INDEX TECHNICAL SERVICE BULLETIN

Alcyon (TM) System Software 1.6 Recall

TSB#: 119-009A

Alcyon® Hardware Upgrade 2

Alignment of Lower Bracket to Upper Bracket

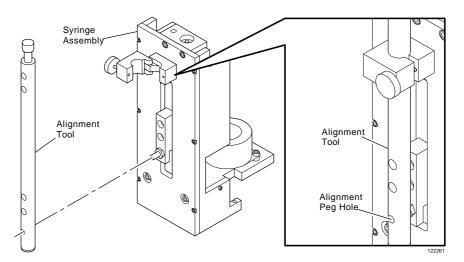
A tool has been released to align the new lower support to the upper bracket. Before installing the lower support, verify the post is secured to the bracket.

- 1. Remove the lower bracket on the syringe drive, then install the new lower support. Do not tighten the screws.
- 2. Move the syringe drive to the bottom of its travel so that it is approximately 1.5mm (1/16") from the bottom of the slot in the front of the syringe drive. The syringe support must not contact the bottom of the slot.
- 3. Use the syringe alignment tool to align the lower bracket to the upper bracket as shown below. Tighten the screws to secure the lower bracket.

Installation of New Syringe

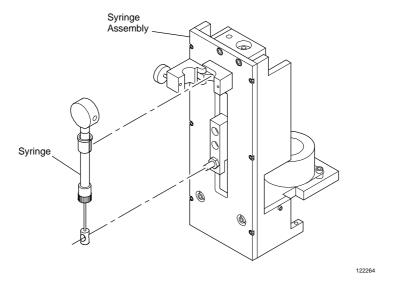
New Syringe Assemblies

1. Install the new syringes as shown below. Verify the circle "T" is secured to the each syringe.

Figure 12.

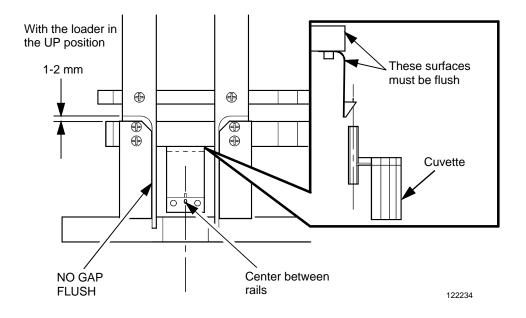
1. Verify all dimensions are met as shown in Figure 12.

Figure 2.

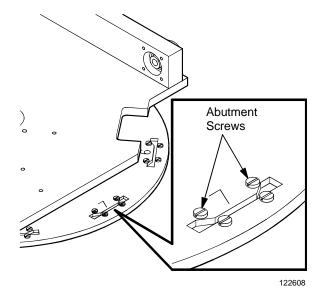
2. Check the abutments in the reaction carousel by inserting the above a modified cuvette in each of the 9 locations of the reaction carousel. Adjust the abutments so the cuvettes are snug, not tight, in the carousel. See Figure 2.
